PLANNING & ZONING APPROVAL

WATER AND SEWER PERMIT  
REPLACEMENT

Southeastern  
District Health Department *LM*

DIAGRAM

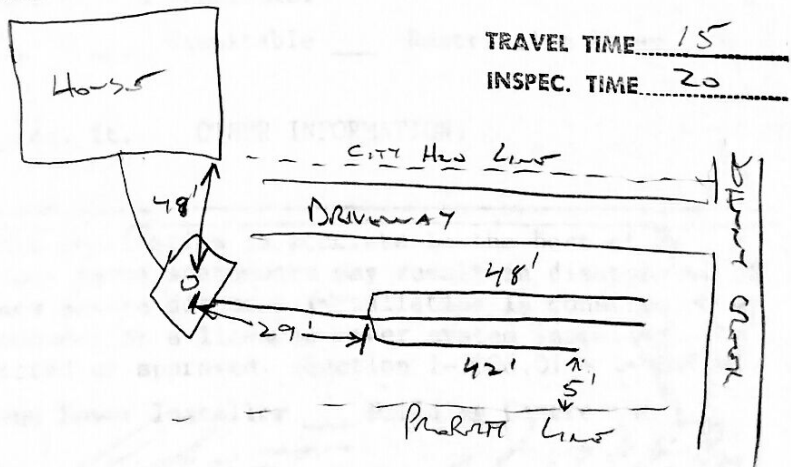
Would need 400 sq ft with Infiltrators  
For Example 2 Trenches 70x3  
Example for a bed 17x40'  
Does not meet distance to City H<sub>2</sub>O Line but Ok as No other alternative exists and this is a replacement system.
